WATERVIEW EAST COMMERCIAL

CONSTRUCTION DOCUMENTS

WATERVIEW EAST COMMERCIAL FILING NO. 1
CONSTRUCTION DOCUMENTS
COVER SHEET

WATERVIEW EAST COMMERCIAL FILING NO. 1
CONSTRUCTION DOCUMENTS
OVERALL GRADING PLAN

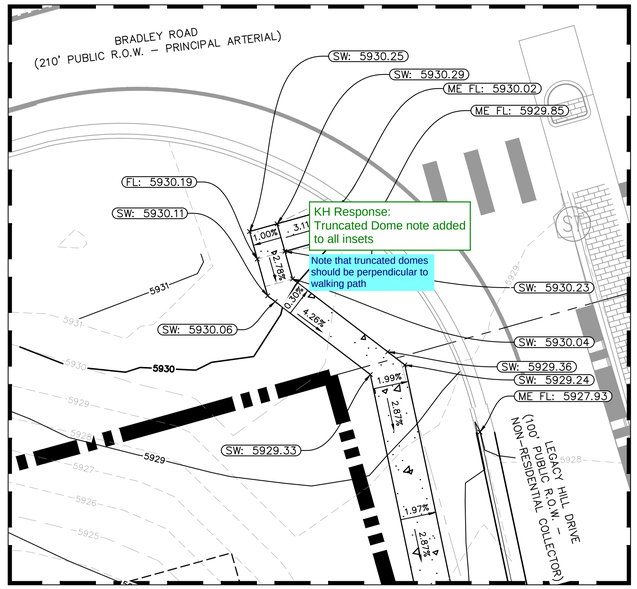
Finished grade contours should tie into existing grade contours. Please revise grading.

Extend inset to show existing ramp and crosswalk

Provide slope call outs on anything 4:1 pr steeper

KH Response:
Finished grade contours updated to tie into existing grade contours

KH Response:
Inset A has been extended to show existing ramp and crosswalk.

KH Response:
4:1 slopes and greater have been called out

KH Response:
Insets D & E have been combined as Inset C.

INSET A
SCALE: 1" = 10'

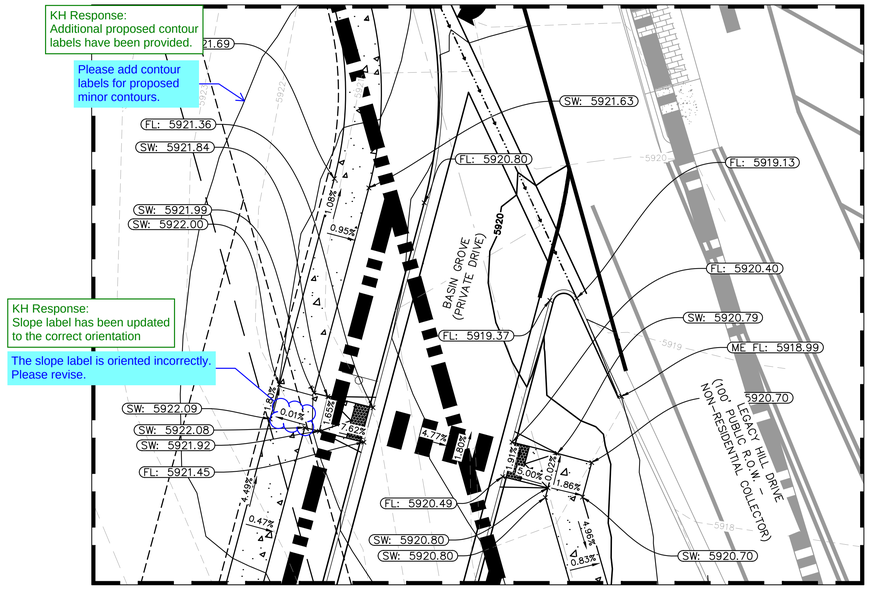
Extend view

KH Response:
Inset A has been extended to show existing ramp and crosswalk.

INSET D
SCALE: 1" = 10'

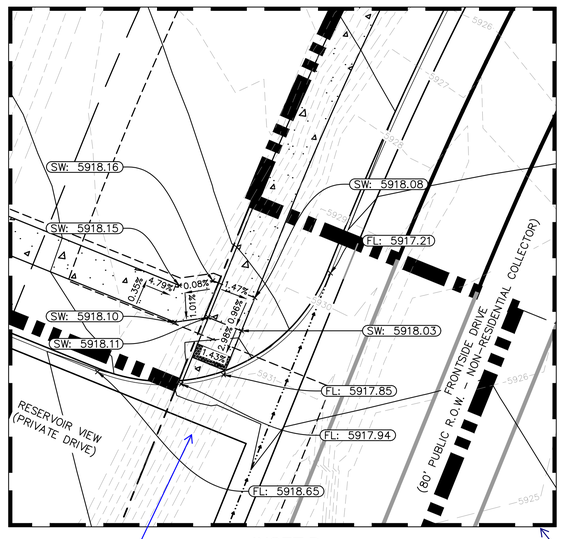
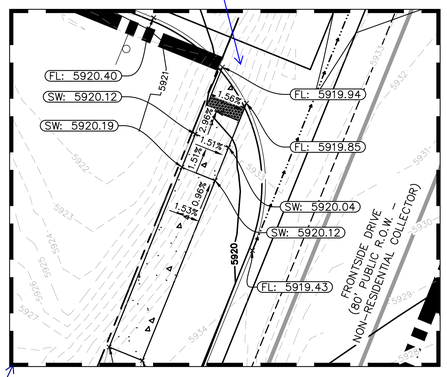
Please provide pedestrian street crossing running slope and cross slope labels.

Please provide pedestrian street crossing running slope and cross slope labels.

KH Response:
Slope labels added on street crossing.

KH Response:
Slope labels added on street crossing.

SHEET
C3.2

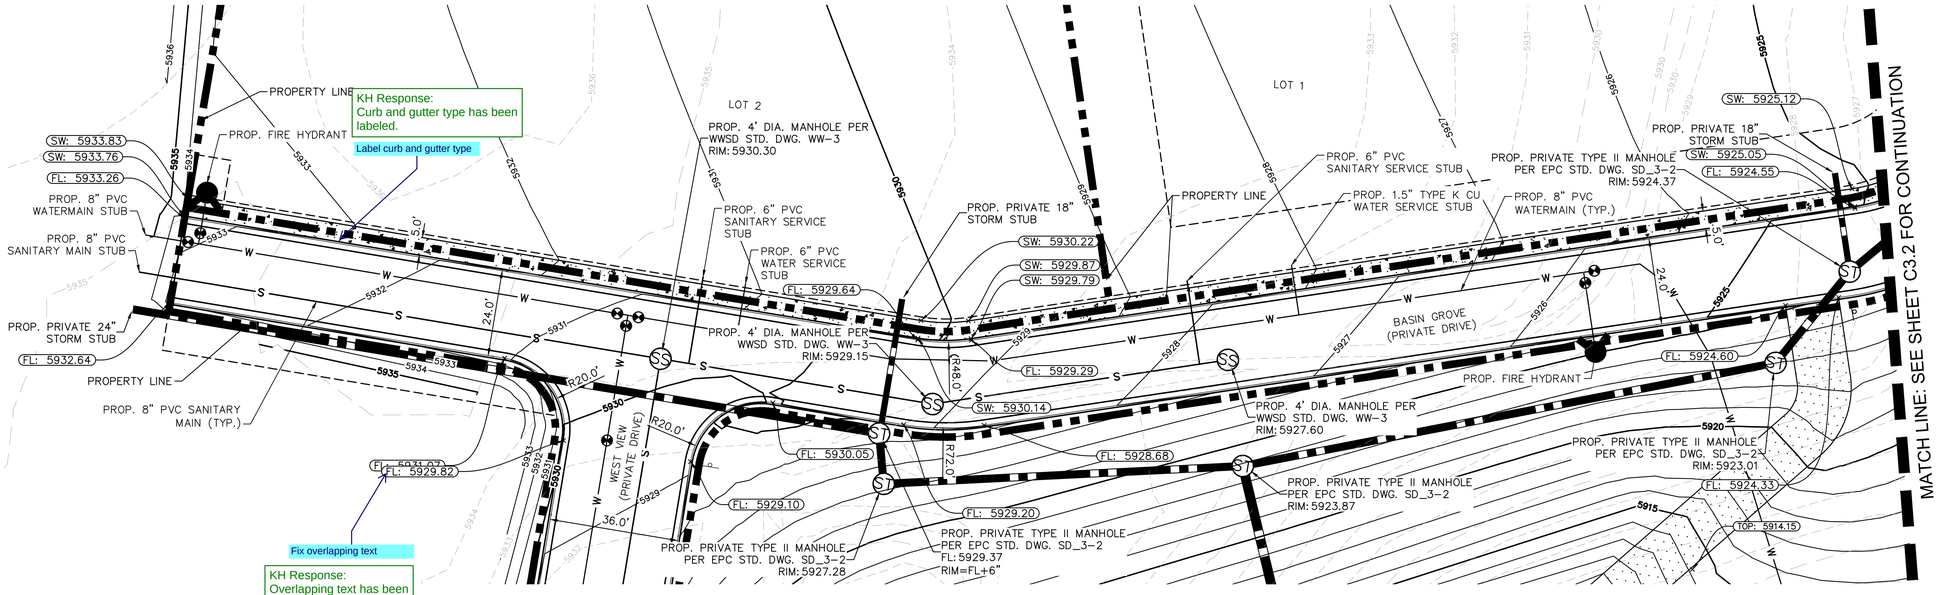
Please provide typical cross-section for Legacy Hill Drive

In addition to what is shown currently in the street plan view, include:
- station equation at alignment intersections
- road design speed

Provide street profile view, which shall include at minimum:
- existing ground profile at centerline
- finished grade profile at centerline and/or flowline
- existing and proposed utility crossings
- station labels at the bottom of profiles
- profile data labels: slope, vertical curve, grade break

KH Response:
Profile view added showing pertinent profiles and utility crossings.

WATERVIEW EAST COMMERCIAL FILING NO. 1
CONSTRUCTION DOCUMENTS
FRONTSIDE DRIVE

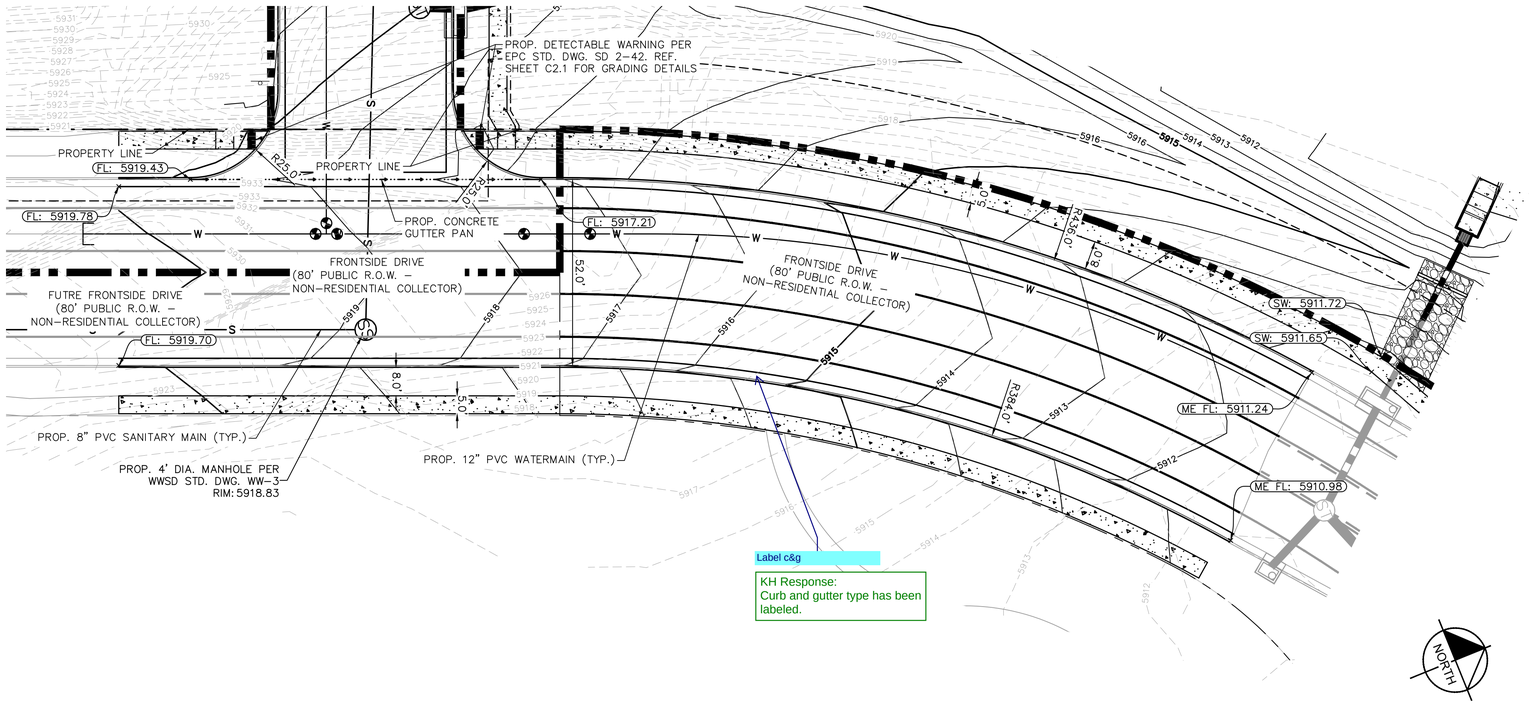
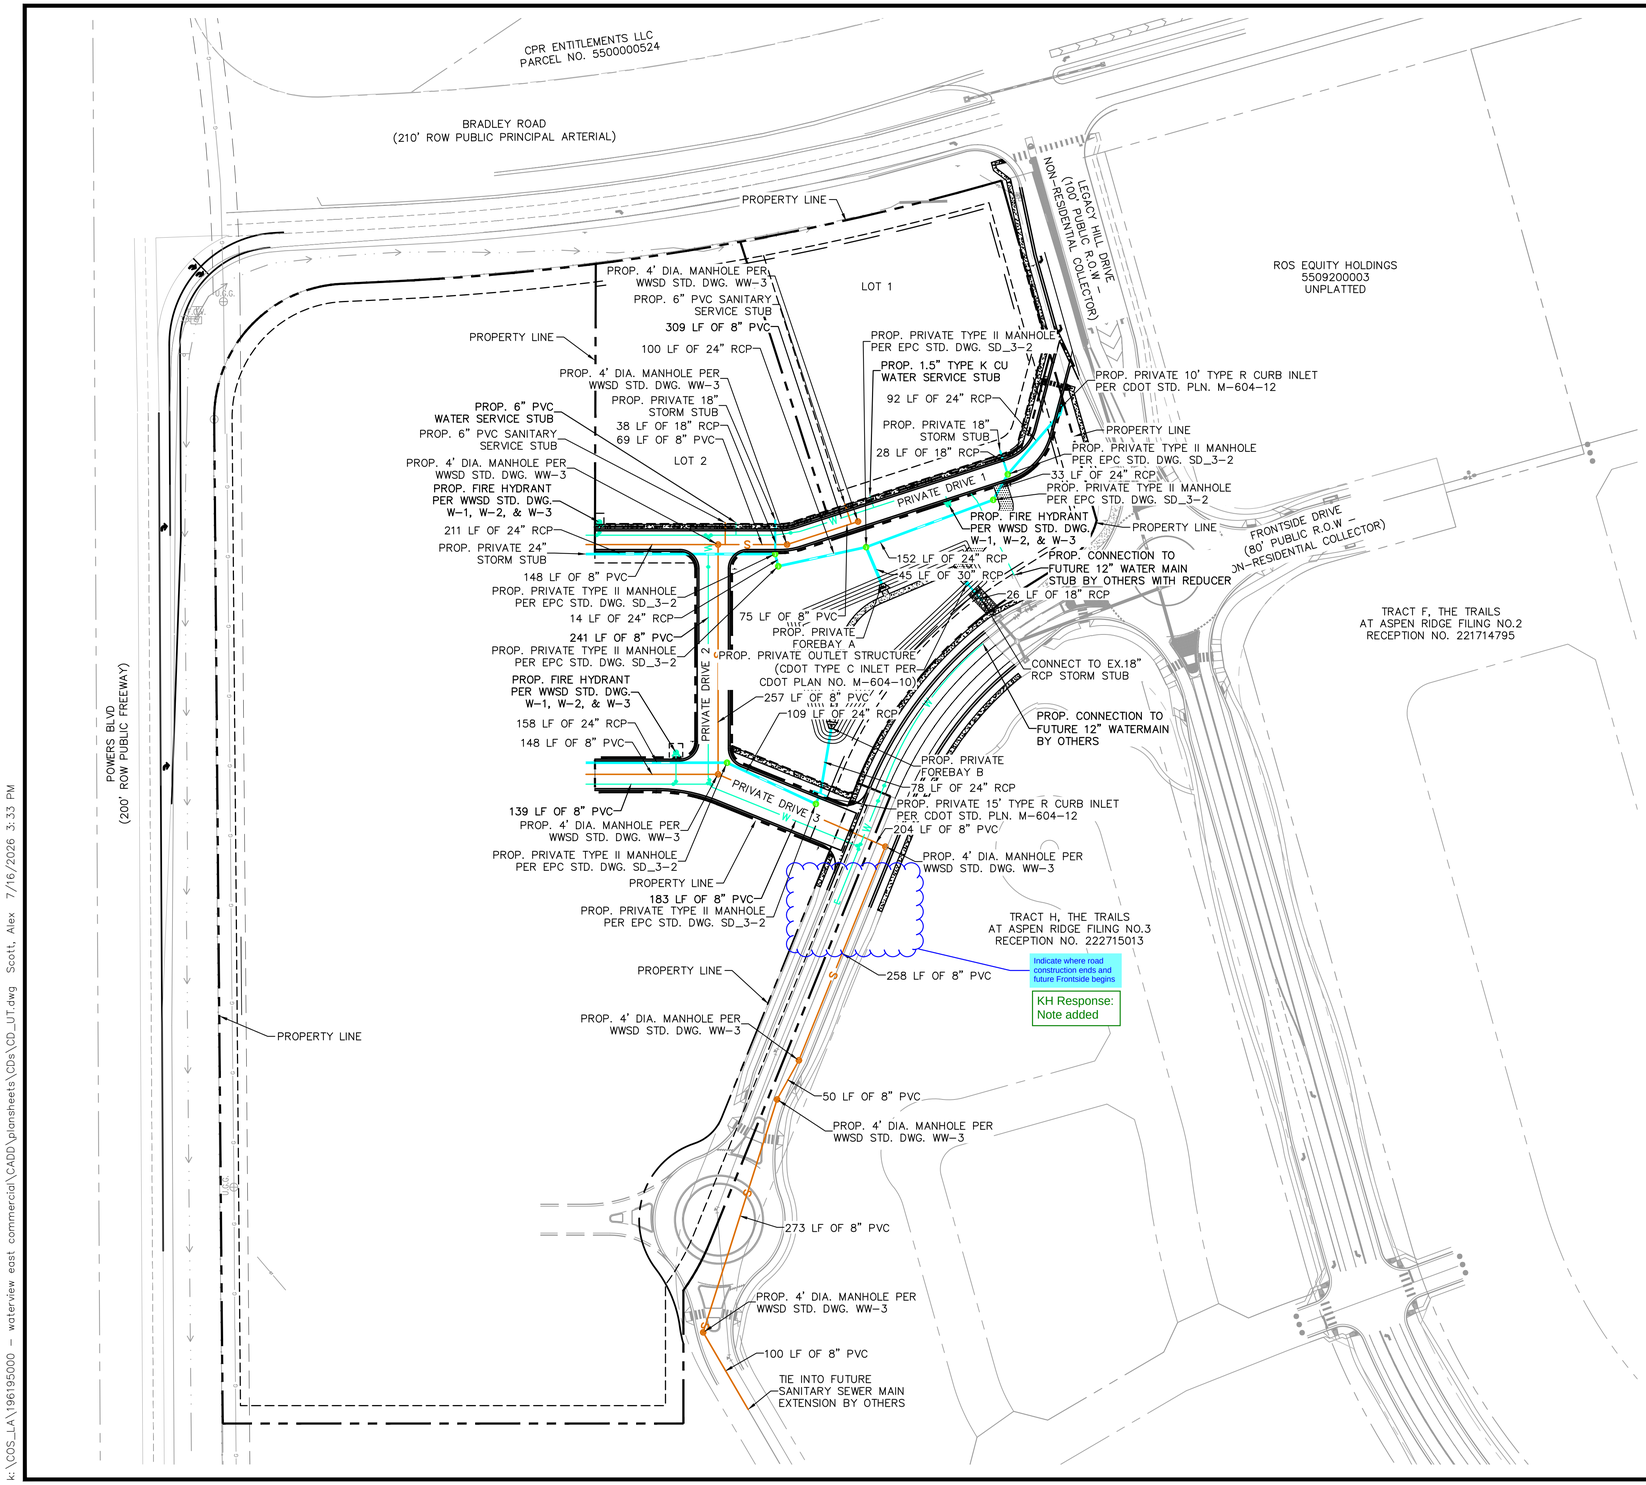
Please provide typical cross-section for Frontside Drive

In addition to what is shown currently in the street plan view, include:
- station equation at alignment intersections
- road design speed

Provide street profile view, which shall include at minimum:
- existing ground profile at centerline
- finished grade profile at centerline and/or flowline
- existing and proposed utility crossings
- station labels at the bottom of profiles
- profile data labels: slope, vertical curve, grade break

KH Response:
Frontside Dr. to be designed by Matrix w/ next filing of Aspen View Homes.

SANITARY SEWER PLAN

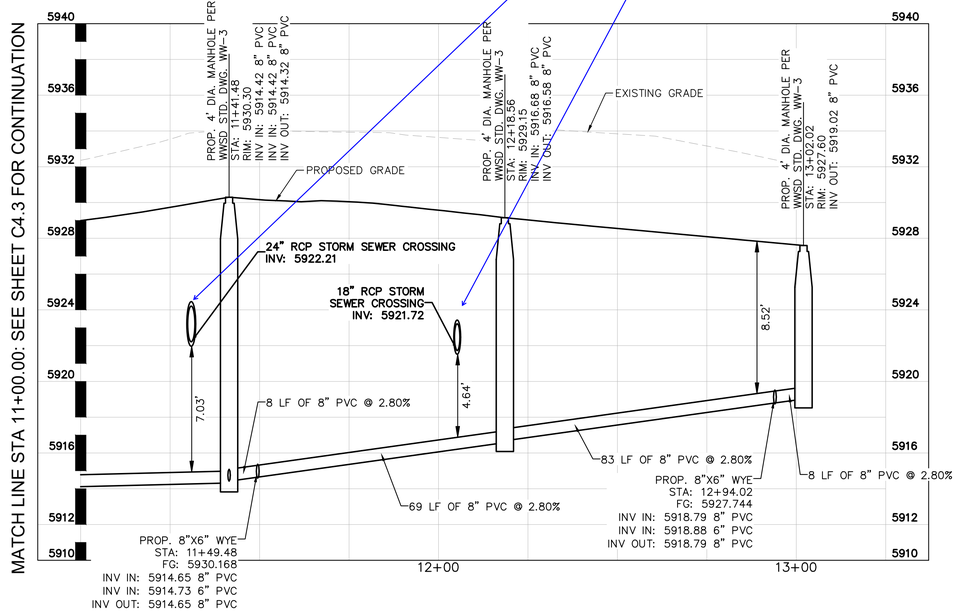
Plan view only shows 1 storm crossing SS. Please revise plan or profile as needed

KH Response:
Updated plan and profiles to more clearly reflect run of pipe being shown.

POND A OUTFALL PLAN

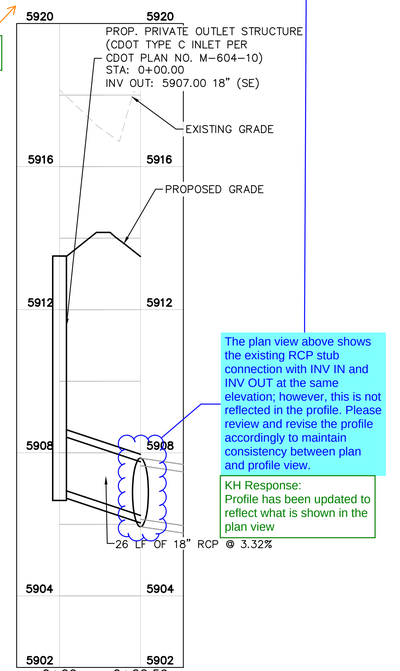
The plan view above shows the existing RCP stub connection with INV IN and INV OUT at the same elevation; however, this is not reflected in the profile. Please review and revise the profile accordingly to maintain consistency between plan and profile view.

KH Response:
Label updated to "Pond P".

KH Response:
Profile has been updated to reflect what is shown in the plan view
